## ***Interactive comment on “Analysis of the PKT correction for direct CO<sub>2</sub> flux measurements over the ocean” by S. Landwehr et al.***

**J. Prytherch (Referee)**

Received and published: 15 November 2013

**Fig. 1.** Figure R1. Individual (grey) and binned (black triangles) CO<sub>2</sub> fluxes calculated using Eq. (7), compared with the iterative PKT method ( $R^2 = 0.98$ ) (Prytherch et al., 2010a).

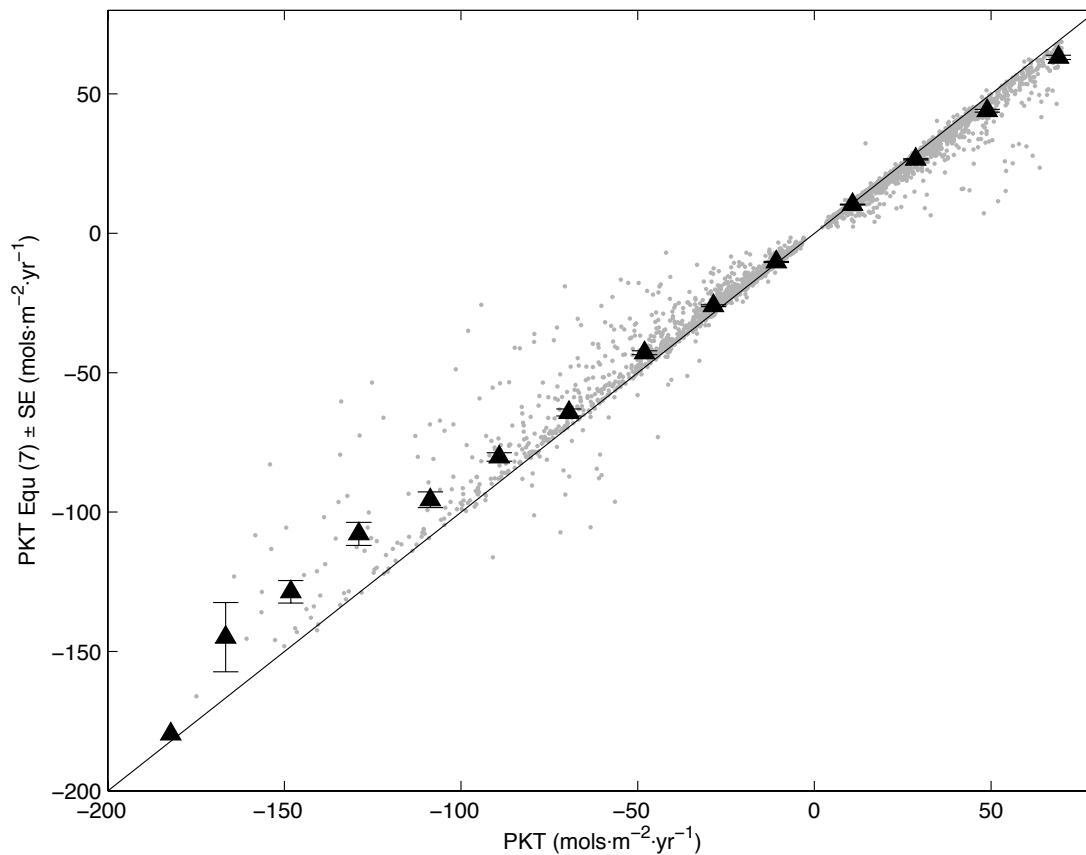
a) It is not clear from the bottom panel of Figure 3 that Eq. (7) obtains similar results to the "standard" PKT correction. We compared Eq. (7) and the standard PKT results from our own air-sea CO<sub>2</sub> flux data (previously published in Prytherch et al., 2010b), and obtained a clear 1:1 relationship ( $R^2 = 0.98$ ), shown in the attached Figure R1 (Measurements in all figures are from the HiWASE field campaign with quality control as described by Prytherch et al. (2010b)). The addition of a similar plot from the authors' data would be much more convincing than the current time series shown in Fig. 3.

**Fig. 2.** Figure R2. CO<sub>2</sub> fluxes calculated using the iterative PKT method using a convergence factor of either 0.5 ('PKT') or 0.75 ('PKT 4'), binned with respect to  $F(0)$ .

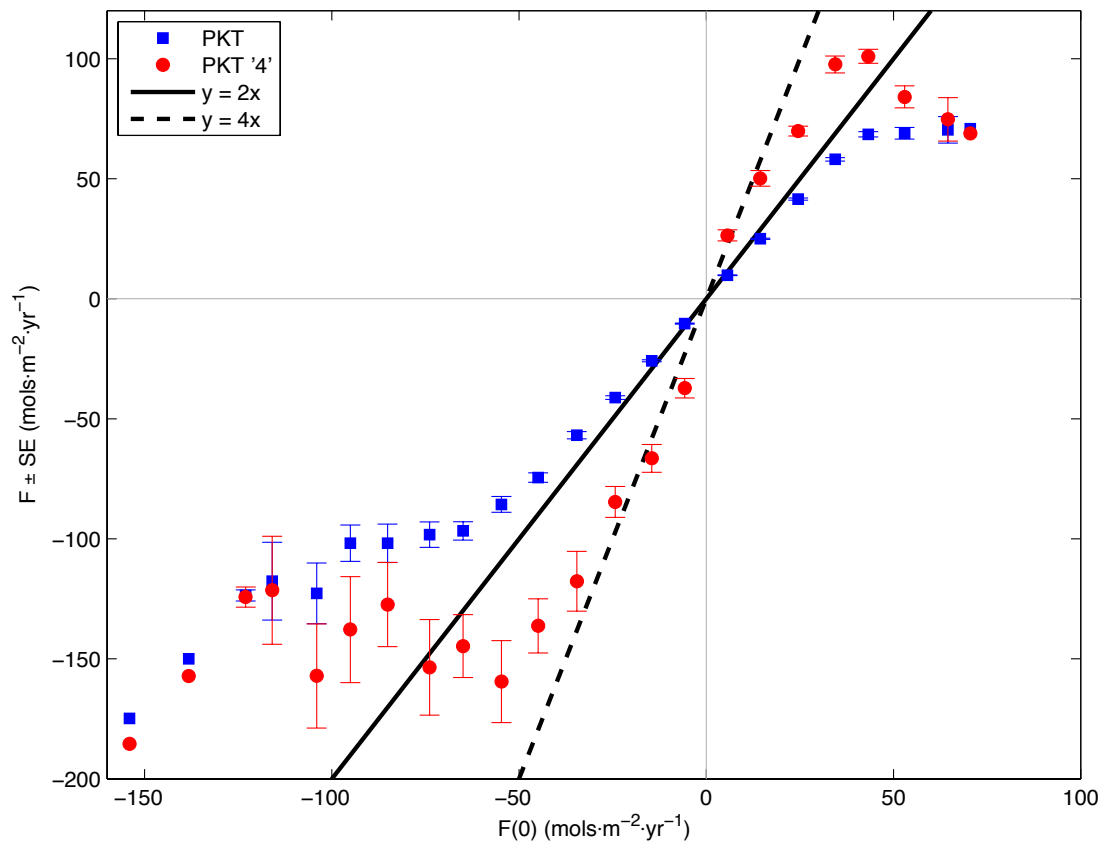
value of this factor. Modifying this value in the iterative PKT correction would provide a convincing validation of Eq. (7) (and hence the invalidity of the PKT correction). We have done this using our flux data, using a factor of 0.75 rather than 0.5 in the original PKT correction. This changes the value of beta from  $\sim 2$  to  $\sim 4$ . The attached Figure R2 shows that the "PKT 4" results are approximately equal to 4 times the detrended flux.

**Fig. 3.** Figure R3. ‘Sonic’, ‘detrended’ and ‘PKT’ heat fluxes binned by sensible heat flux (Prytherch et al., 2010a). ‘PKT 4’ uses a convergence factor of 0.75 rather than 0.5 in the PKT correction.

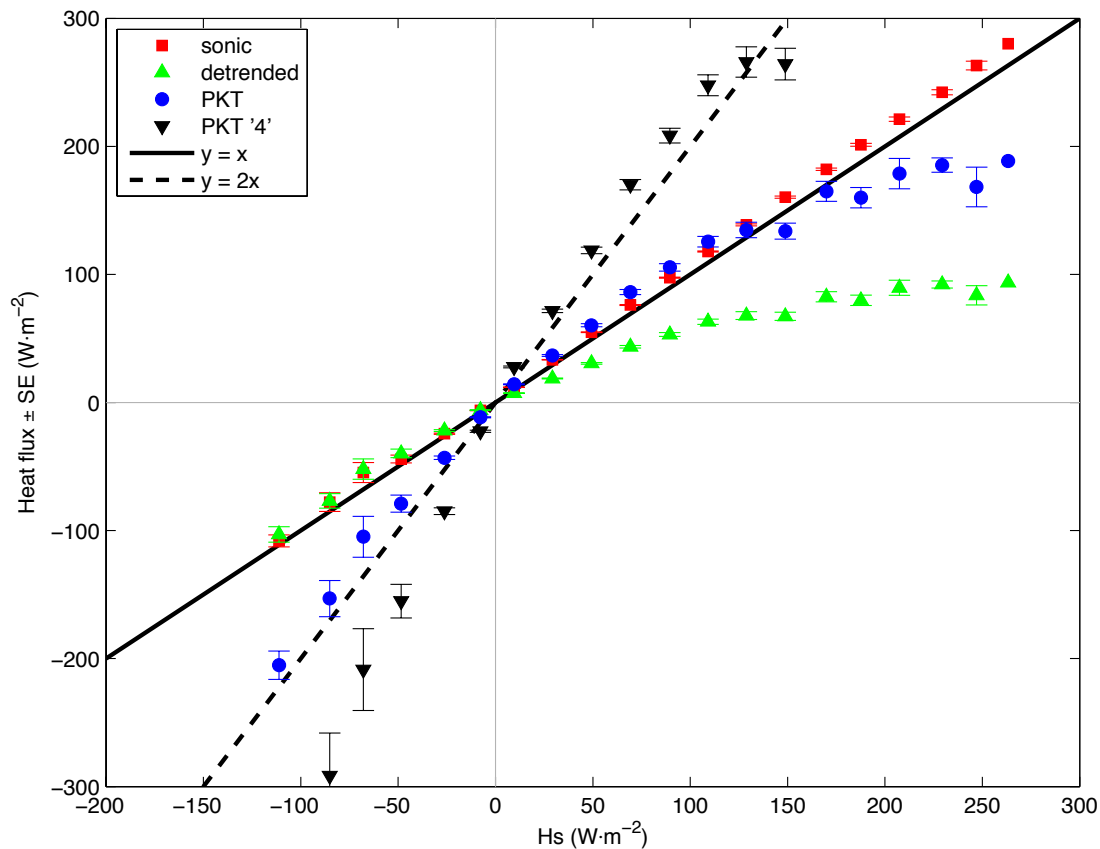
Figure R3 shows that if this factor is used in the sensible heat flux test, then the converged values of the fluxes are twice as large as the actual sensible heat flux. It was a very unfortunate coincidence that the detrended sonic temperature flux was a factor of 2 smaller than the sensible heat flux, and that the factor of 0.5 used in the iteration happened to increase the detrended flux by a factor of 2.
